PUBLIC UTILITIES COMMISSION

RE: Valley South Subtransmission Project: Minor Project Change #5

Attachment A: Location of Proposed Additional Access and Work Areas

VSSP MPR 5 – Additional work areas and access roads

Add work area for SVC Pole across from 4936882E (UNK 163)

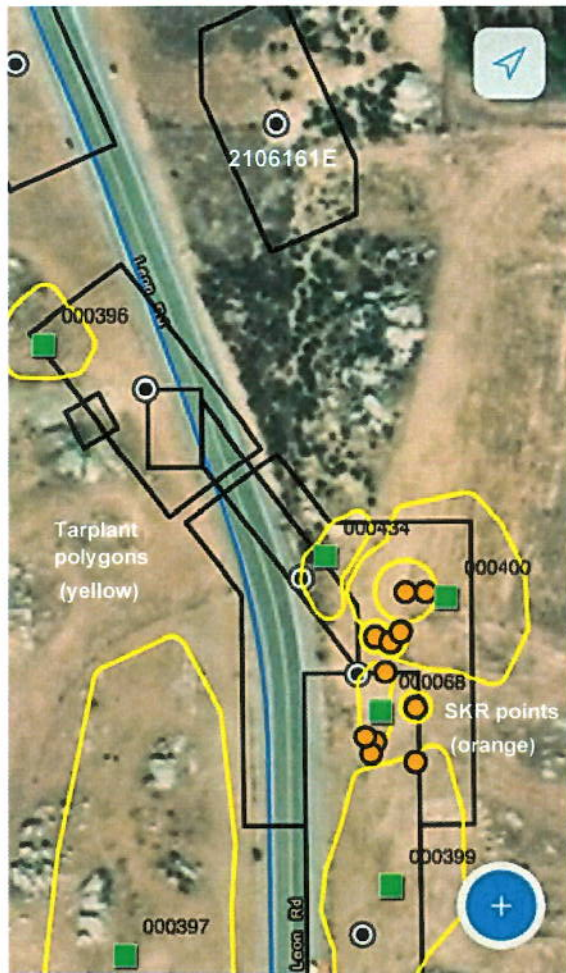
Biological Resources
No resources recorded in the survey area during historical surveys. Paniculate tarplant (FRED ID 117) recorded during preconstruction survey 2. No new resources recorded within the area requested.

Management Strategies
Paniculate Tarplant: A clearance sweep is conducted prior to construction activities. Any new paniculate tarplant observed is mapped and ESA are established. The monitor coordinates with foreman to determine if potential impacts to paniculate tarplant can be avoided to the extent possible. If impacts cannot be avoided, then the monitor documents the number of individuals impacted and the information is noted in the daily monitoring report uploaded to FRED

Add access road to 2106161E

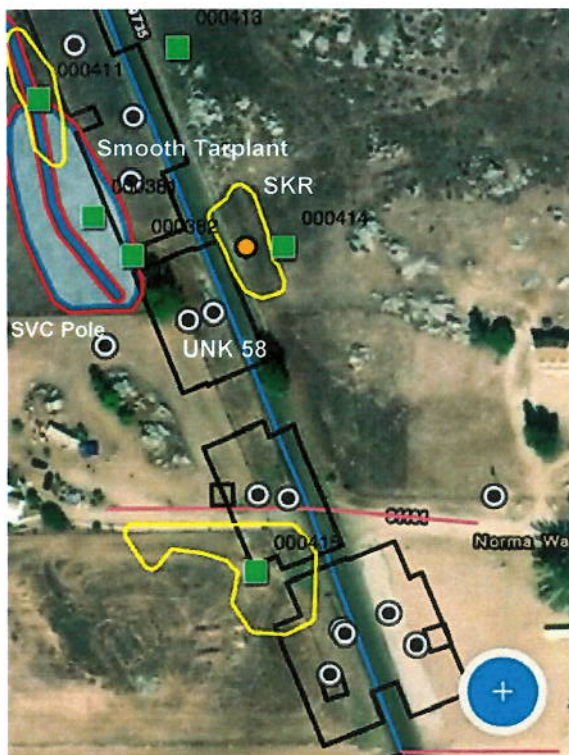
Biological Resources
<p>Paniculate tarplant recorded in the survey area during historical surveys. Potential SKR habitat recorded with the work area for UNK 125. Paniculate tarplant recorded (FRED ID 434, 400, 399) in the during preconstruction survey 6. No new resources recorded within the area requested.</p>

Management Strategies
<p>Paniculate Tarplant: A clearance sweep is conducted prior to construction activities. Any new paniculate tarplant observed is mapped and ESA are established. The monitor coordinates with foreman to determine if potential impacts to paniculate tarplant can be avoided to the extent possible. If impacts cannot be avoided, then the monitor documents the number of individuals impacted and the information is noted in the daily monitoring report uploaded to FRED</p>
<p>SKR: A clearance sweep is conducted prior to construction activities. Any new potential SKR burrows observed within work areas are mapped and ESA buffers are established. The monitor coordinates with the foreman to determine if potential impacts can be avoided to the burrows to the extent possible. If impacts cannot be avoided, then the monitor documents the number of potential burrows impacted, level of impact (i.e. lightly impacted by foot traffic or removed from grading), and the information is noted in the daily monitoring report uploaded to FRED.</p>

Add work area and access road for 4250133E

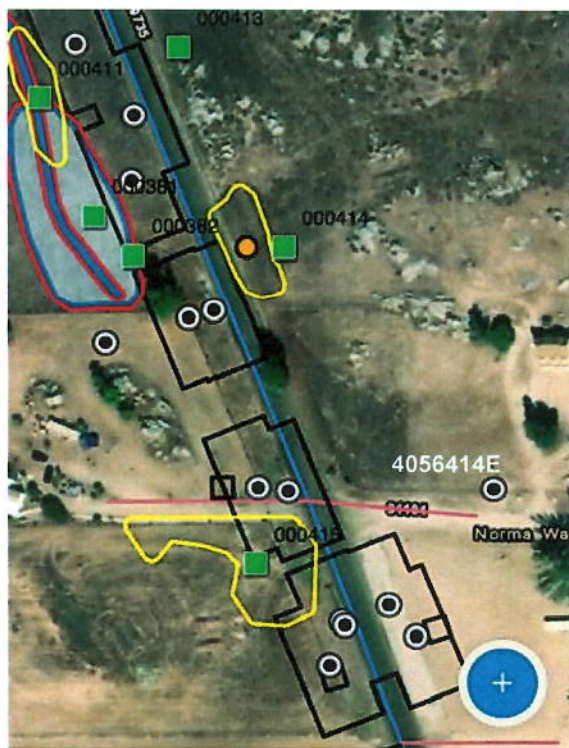
Biological Resources
No resources recorded in the survey area during historical surveys. Potential SKR habitat recorded in the survey area during preconstruction survey 6. No new resources recorded within the area requested.

Management Strategies
SKR: A clearance sweep is conducted prior to construction activities. Any new potential SKR burrows observed within work areas are mapped and ESA buffers are established. The monitor coordinates with the foreman to determine if potential impacts can be avoided to the burrows to the extent possible. If impacts cannot be avoided, then the monitor documents the number of potential burrows impacted, level of impact (i.e. lightly impacted by foot traffic or removed from grading), and the information is noted in the daily monitoring report uploaded to FRED.

Add work area for 4056414E

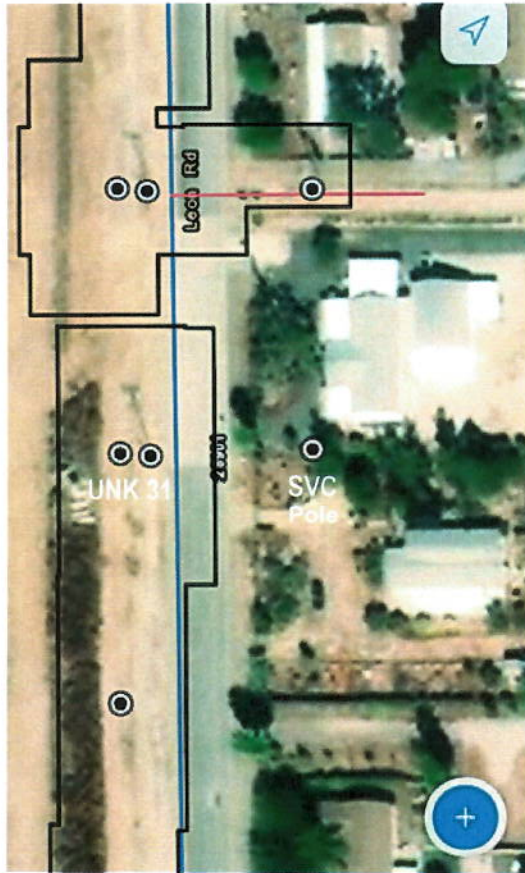
Biological Resources
MSHCP riparian riverine resource and smooth tarplant recorded north of the site during historical surveys. Additional paniculate tarplant recorded (FRED 414, 415) and potential SKR habitat during preconstruction survey 6. No new resources recorded within the area requested.

Management Strategies
Paniculate Tarplant: A clearance sweep is conducted prior to construction activities. Any new paniculate tarplant observed is mapped and ESA are established. The monitor coordinates with foreman to determine if potential impacts to paniculate tarplant can be avoided to the extent possible. If impacts cannot be avoided, then the monitor documents the number of individuals impacted and the information is noted in the daily monitoring report uploaded to FRED
Smooth tarplant: A clearance sweep is conducted prior to construction activities. Any new smooth tarplant observed are mapped and ESA are established. The monitor coordinates with the foreman to determine if potential impacts can be avoided to the extent possible. If impacts cannot be avoided, then the monitor documents the number individuals impacted, and the information is noted in the daily monitoring report uploaded to FRED. Impacts to smooth tarplant will be avoided within the MSHCP Criteria Areas Species Survey Area (CASSA) located south of Scott Road along the Project ROW.

SKR: A clearance sweep is conducted prior to construction activities. Any new potential SKR burrows observed within work areas are mapped and ESA buffers are established. The monitor coordinates with the foreman to determine if potential impacts can be avoided to the burrows to the extent possible. If impacts cannot be avoided, then the monitor documents the number of potential burrows impacted, level of impact (i.e. lightly impacted by foot traffic or removed from grading), and the information is noted in the daily monitoring report uploaded to FRED.

Add work area and access road for SVC Pole across from 4936526E (UNK 31)

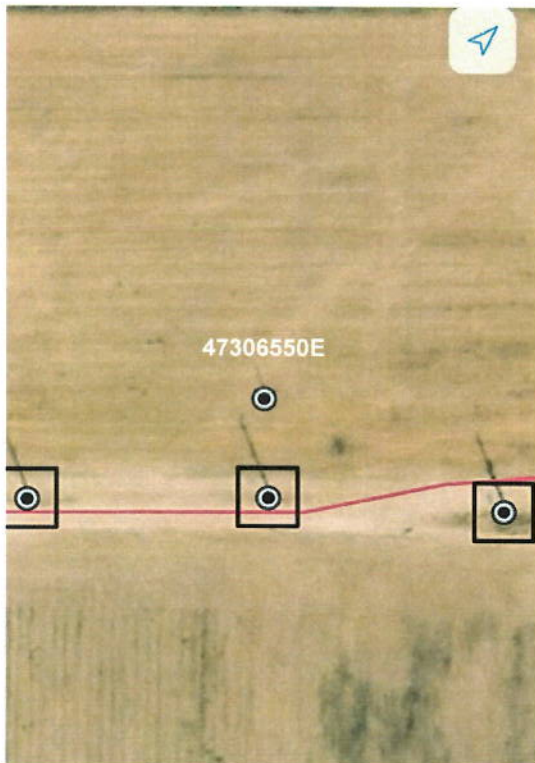
Biological Resources

No resources recorded in the survey area during historical surveys. No resources recorded during preconstruction survey 5 within the area requested.

Add work area and access road for 47306550E

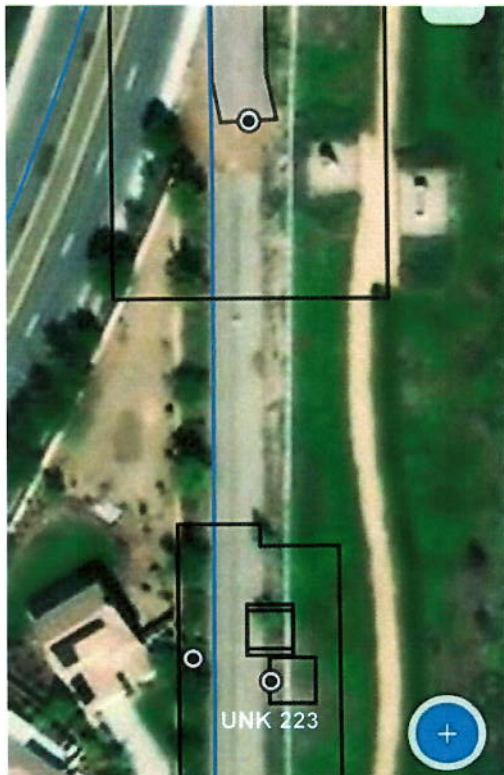
Biological Resources
MSHCP riparian riverine resource recorded southwest of the site during historical surveys. No new resources recorded during preconstruction survey 4 within the area requested.

Management Strategies
MSHCP Riparian Riverine Resource: All riparian/riverine resources will be avoided. The ESAs are established in the field. The monitor coordinates with the foreman to ensure boundaries are clear prior to starting work.
